STATE OF OHIO
CITY OF CANTON
STA-0153-01.70
MAHONING ROAD NE
ROADWAY IMPROVEMENTS
G.P. 1103

THE PROJECT WORK INVOLVES THE IMPROVEMENT OF APPROXIMATELY 0.67 MILES OF MAHONING ROAD NE, S.R. 153 BETWEEN THE GRACE AVENUE NE AND HARMONT AVENUE NE INTERSECTIONS. THE IMPROVEMENTS INCLUDE NEW STORM SEWERS, CURBS, SIDEWALKS, PLANTERS, SIGNAGE, AND STREET LIGHTING.

REVISIONS	DATE	BY
CONSTRUCTION BIDDING SET	4/21/14	GEA
ADDENDUM NO. 1	5/7/14	GEA

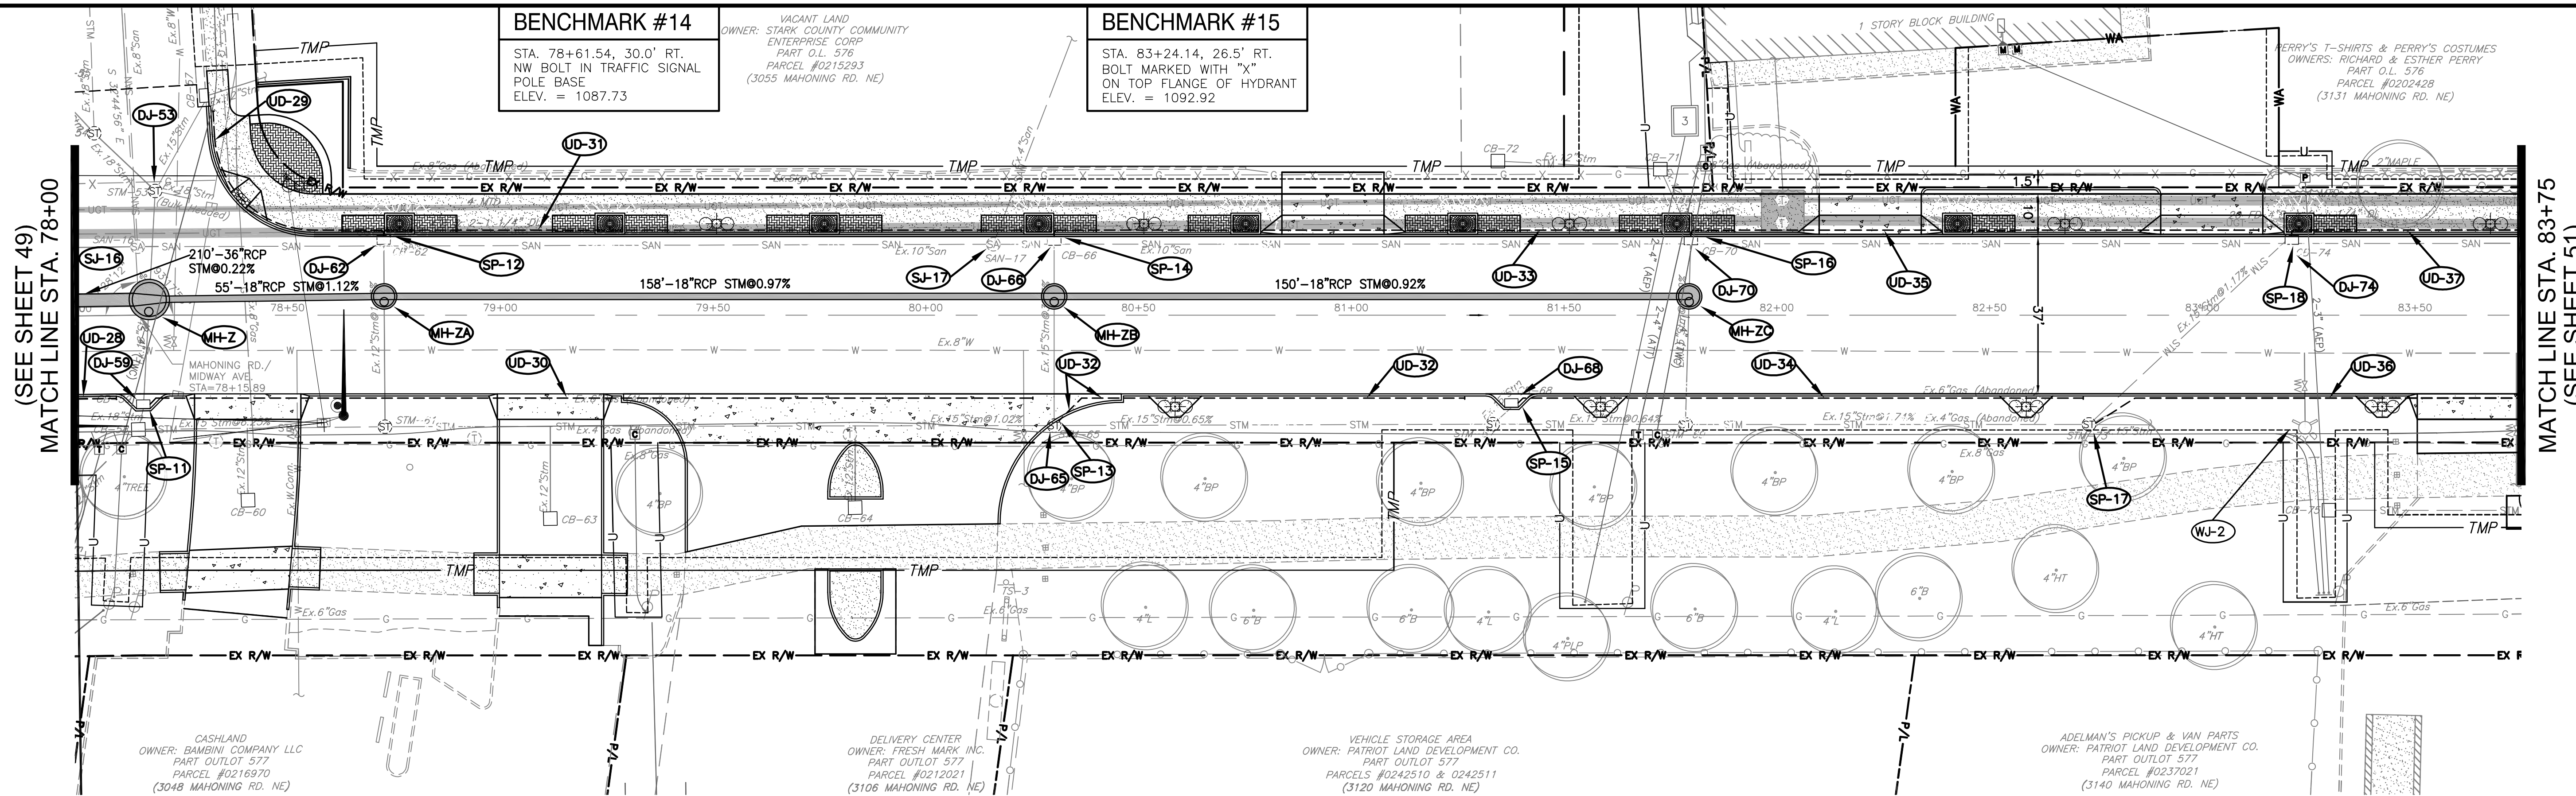
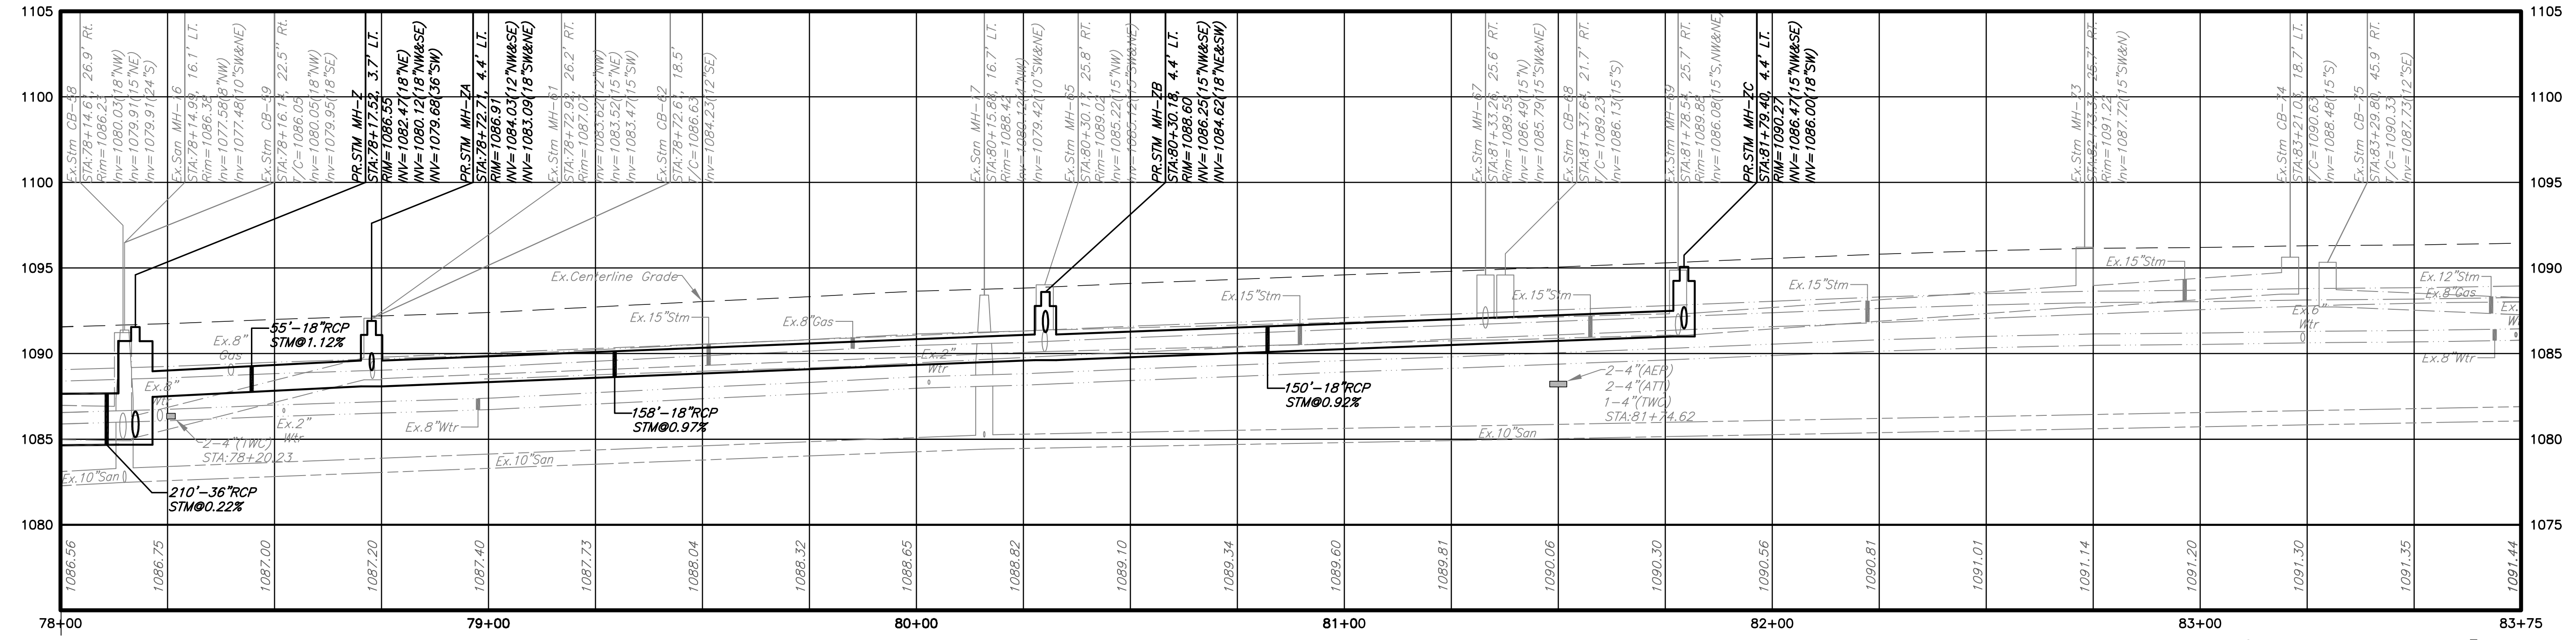
REVISIONS TO THIS SHEET INCLUDED:

- ADDED ADDITIONAL CALL OUT ITEMS TO MATCH SUB-SUMMARY TABLES ON SHEETS 21 THRU 40.
- REVISED HATCHING DESIGNATING DIFFERENCE BETWEEN DRIVE APRONS AND SIDEWALK.

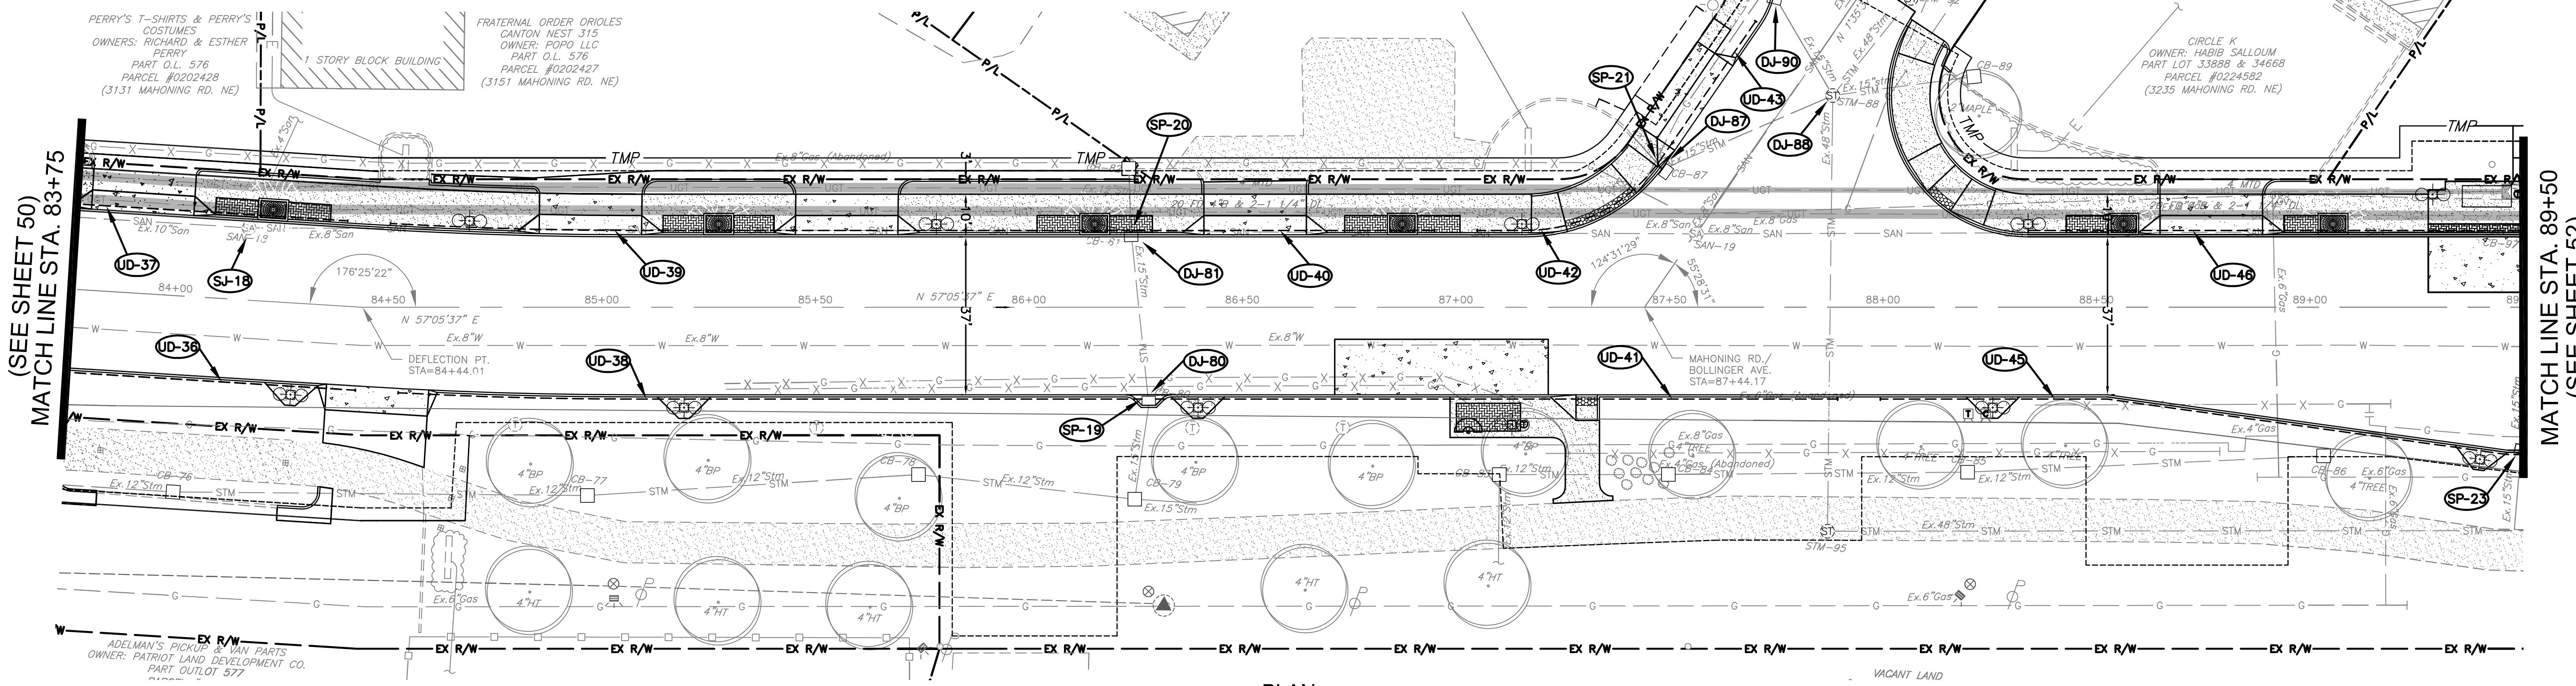
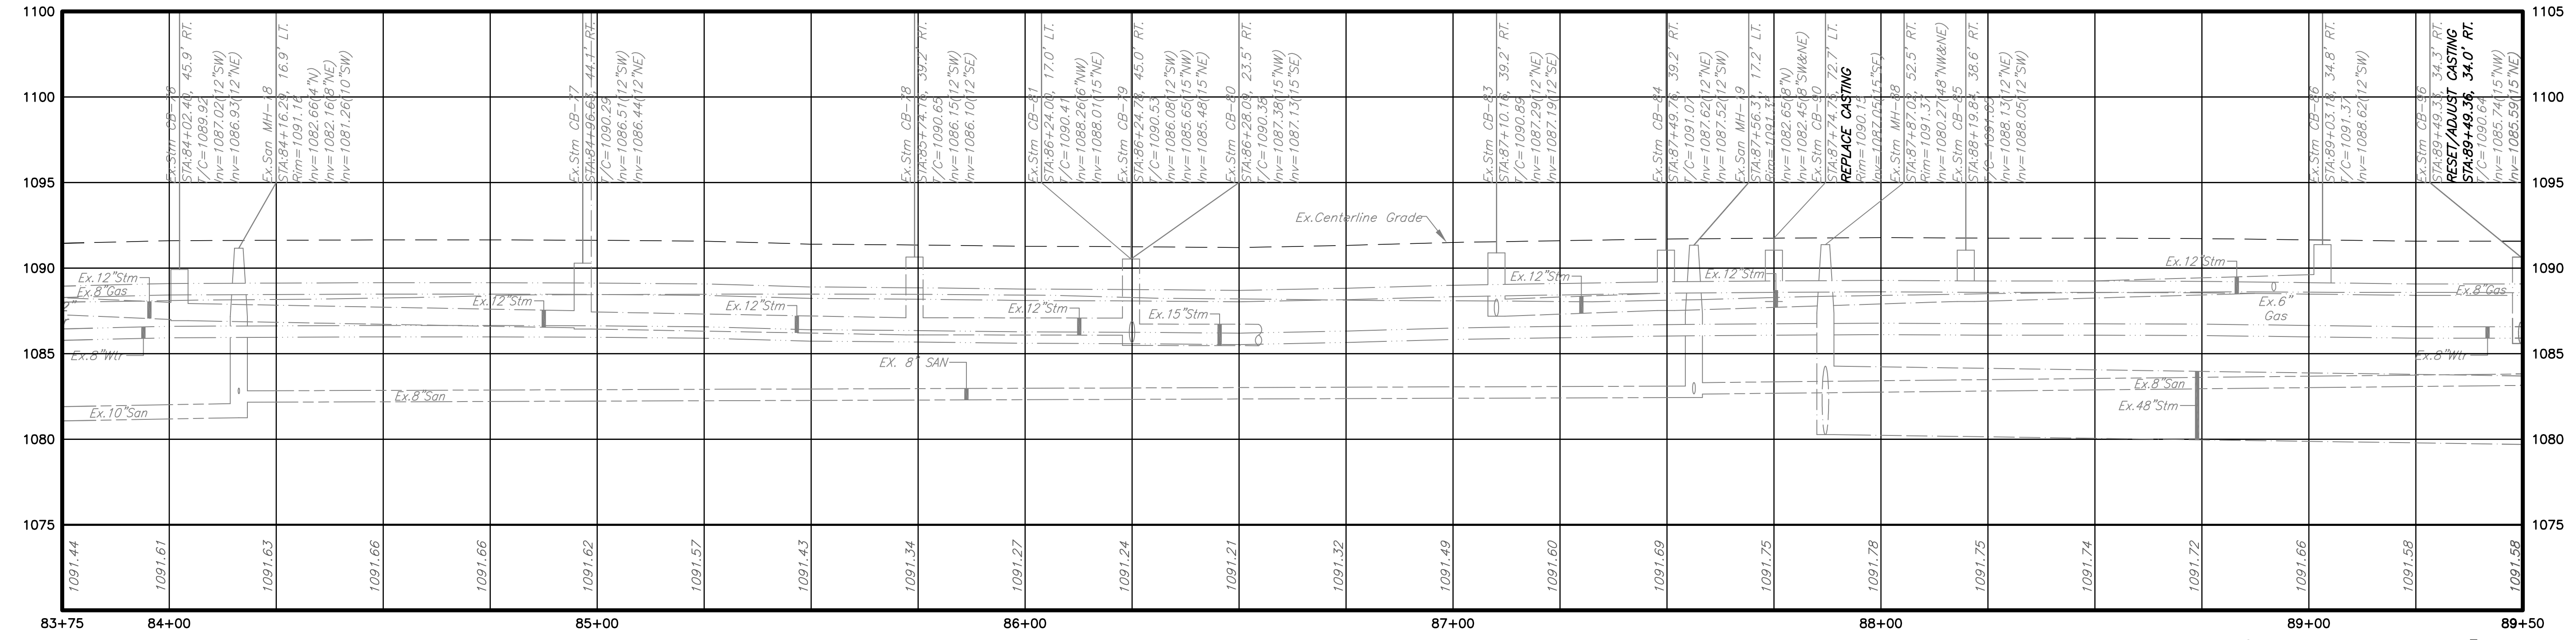
REVISIONS TO THIS SHEET INCLUDED:

- ADDED ADDITIONAL CALL OUT ITEMS TO MATCH SUB-SUMMARY TABLES ON SHEETS 21 THRU 40.
- REVISED HATCHING DESIGNATING DIFFERENCE BETWEEN DRIVE APRONS AND SIDEWALK.

PLAN & PROFILE
STA. 89+50 TO STA. 95+50

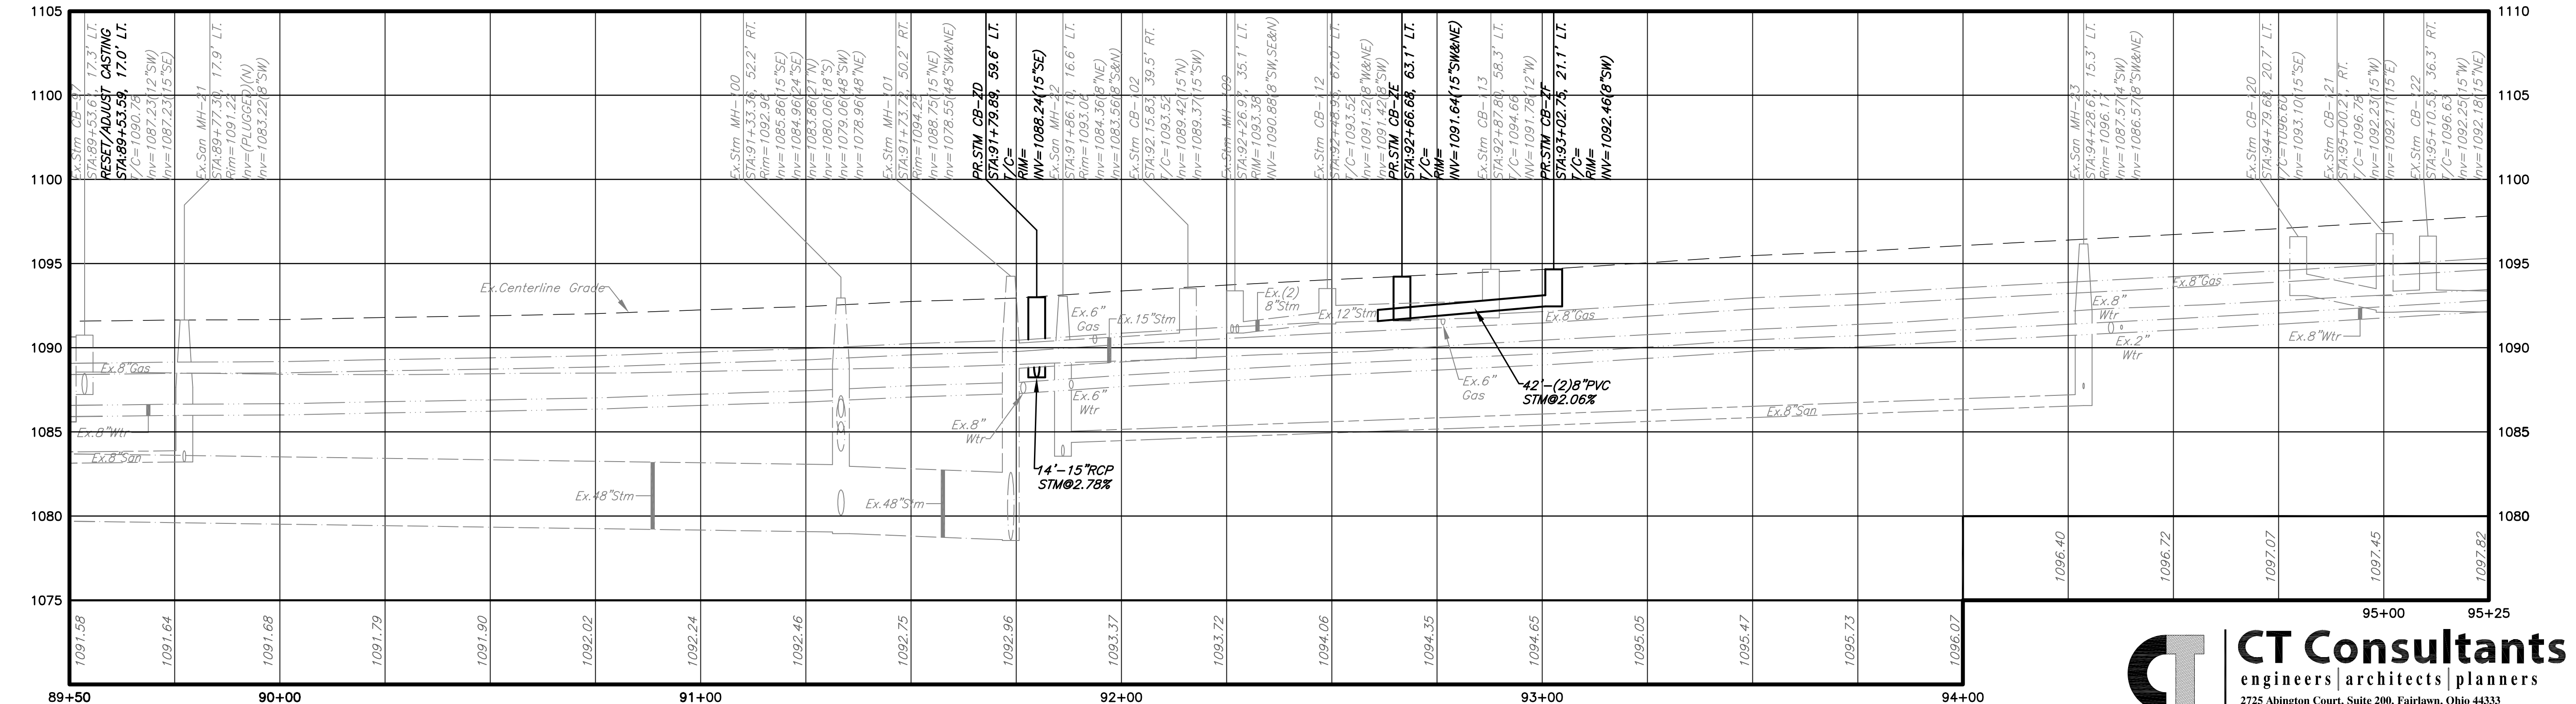
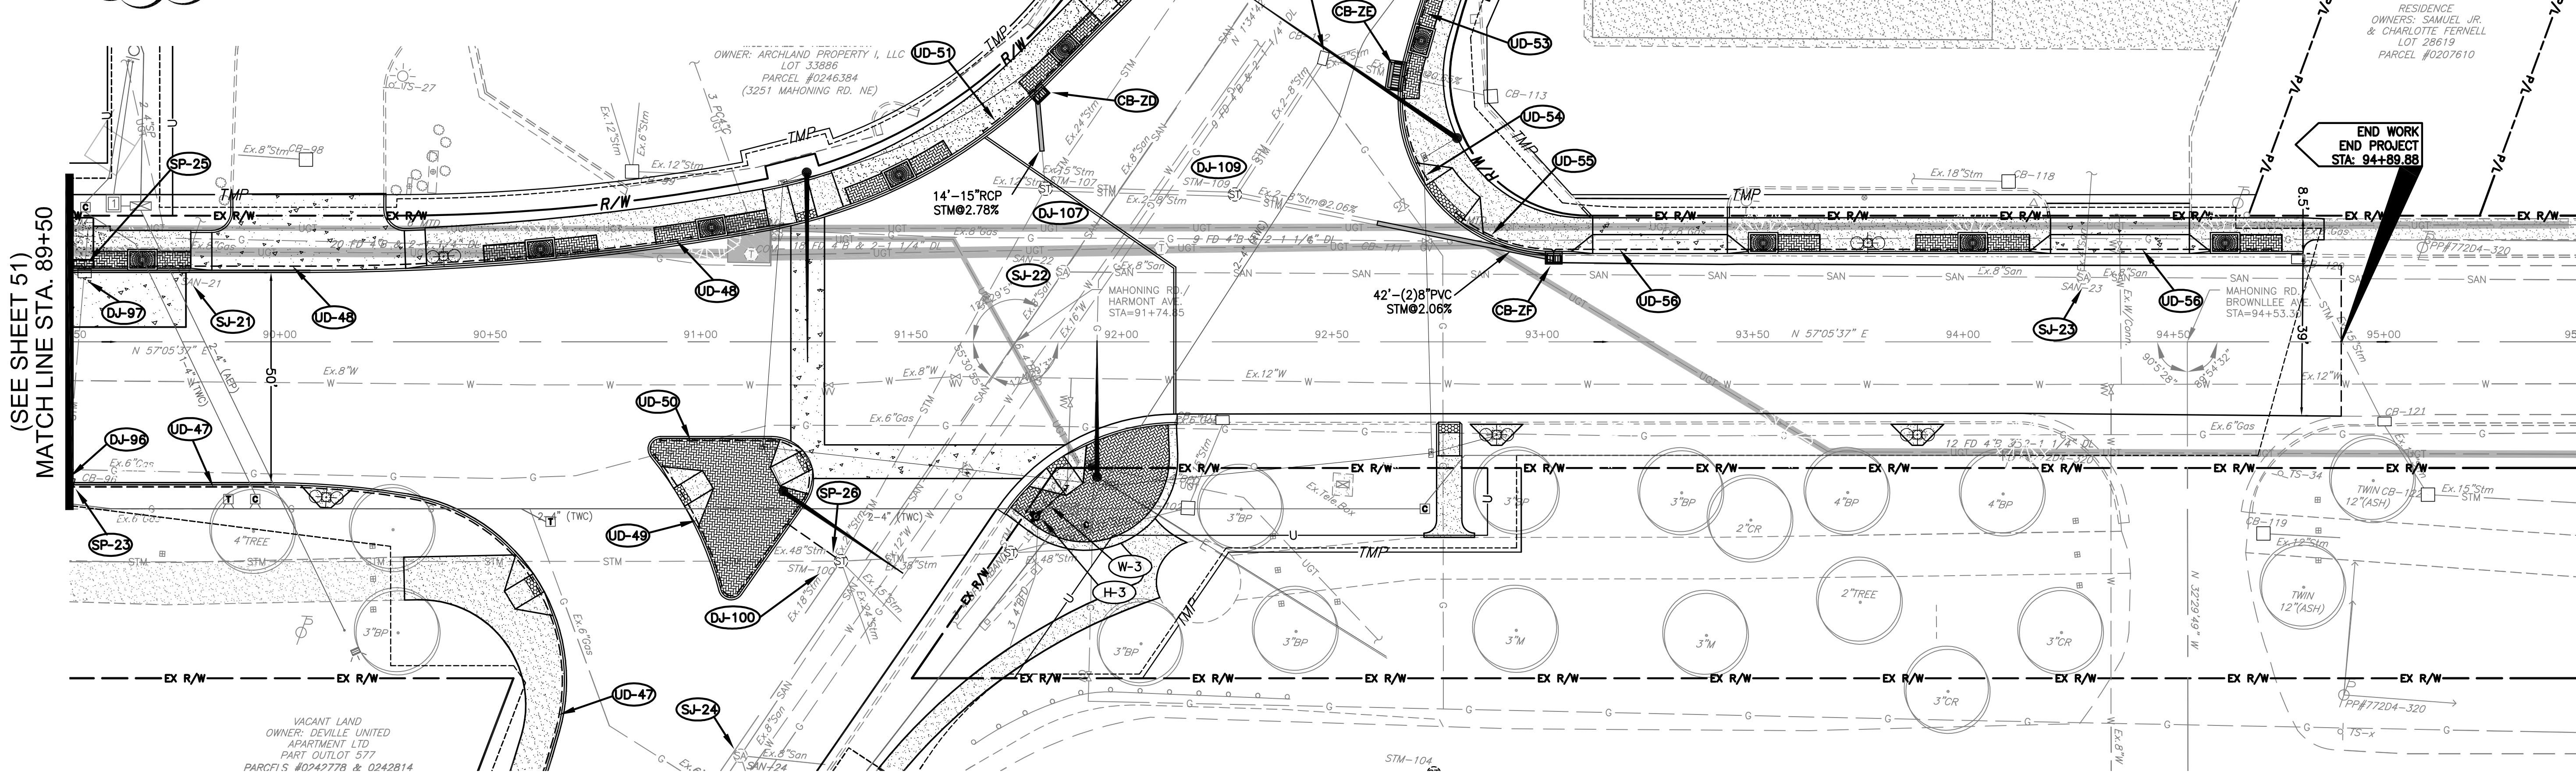
- ADDED LEGEND.
- ADDED ADDITIONAL CALL OUT ITEMS TO MATCH SUB-SUMMARY TABLES ON SHEETS 21 THRU 40.
- REVISED HATCHING DESIGNATING DIFFERENCE BETWEEN DRIVE APRONS AND SIDEWALK.
